Grand St Commons/Mt Baker Housing Alley Vacation

**Office of Planning and
Community Development**
Seattle City Hall
600 4th Avenue, 5th Floor
Seattle, WA 98124

Meeting Summary

May 6, 2021

Figure 2: Updated Design Proposal

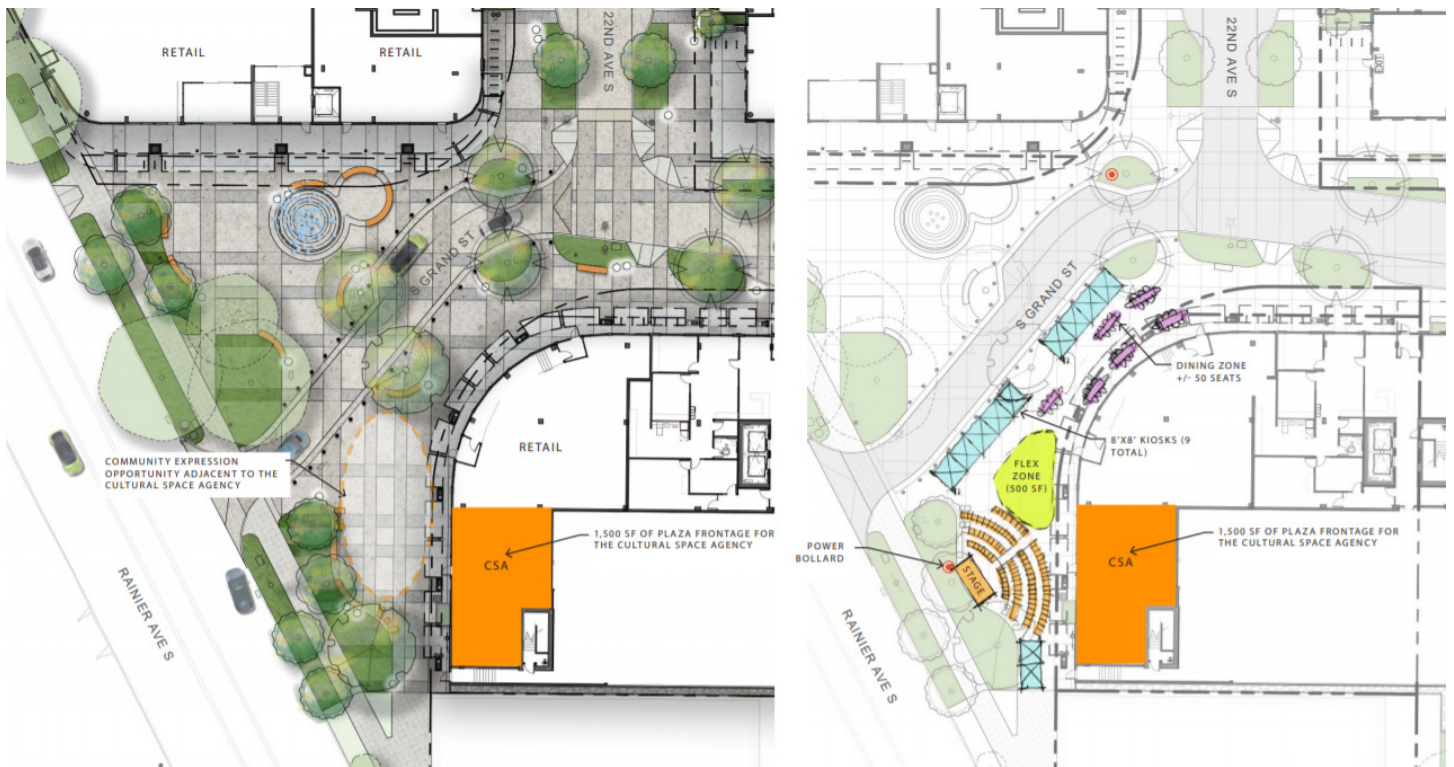
The Commission then discussed the updated location and design of Grand St, which bisects the plaza as well as updated information provided by SDOT stating the possibility that the road could be eliminated. The necessity of the road was discussed, and, while most believed that there was value in retaining it to support the retail businesses, there were differing opinions of the necessity of the road to break up the open area of the plaza. There was agreement that if the road were to be removed, the organization of the space and design of the plaza would need to be reconsidered. Commissioners then encouraged the team to consider refining the design of the road as much as possible to facilitate safe pedestrian movement where vehicles will be traveling and maneuvering. They asked that alternatives to bollards be used to define the travel route for cars, such as trees or plantings. The Commission then commended the project team for expanding the expanded vegetated buffer near Rainier Ave S. Commissioners said that the team was responsive to earlier comments provided by the SDC having a visual and sound barrier would be fundamental to the usability of the space by the community.

The SDC then discussed refinements to the plaza design. Commissioners appreciated the use of programming diagrams to better understand how the space would be used. Commissioners expressed appreciation for extending the plaza paving eastward along Grand Street, because it would integrate the public space better with the overall development and draw people to the plaza. Commissioners also appreciated the addition of power outlets.

2. Strongly reconsider the use of bollards to separate the curbless street from the plaza; consider using other elements such as trees, that better integrate with the surrounding environment.

3. If the roadway through the plaza is retained, consider the anticipated vehicular volumes and movements, and adjust the roadway design to improve the safety of pedestrian movement, such as by tightening up radii of vehicular movements as possible.)

4. If the road is eliminated, redesign the plaza.
5. For the future, the City is advised to require pedestrian crossings of arterials such as Rainier Ave S when amenities are planned that will serve the broader community and to link TOD developments to transit stops.
